# MICROCHIP PIC18F2410/2510/4410/4510

## PIC18F2410/2510/4410/4510 Rev. B3 Silicon Errata

FIGURE 1: SCK PULSE VARIATION USING TIMER2/2

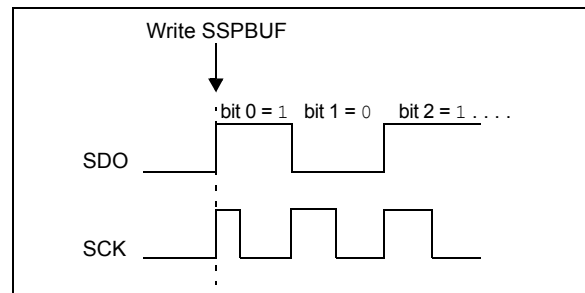
When the SPI is using Timer2/2 as the clock source, a shorter than expected SCK pulse may occur on the first bit of the transmitted/received data (Figure 1).

To avoid producing the short pulse, turn off Timer2 and clear the TMR2 register, load the SSPBUF with the data to transmit and then turn Timer2 back on. Refer to Example 1 for sample code.
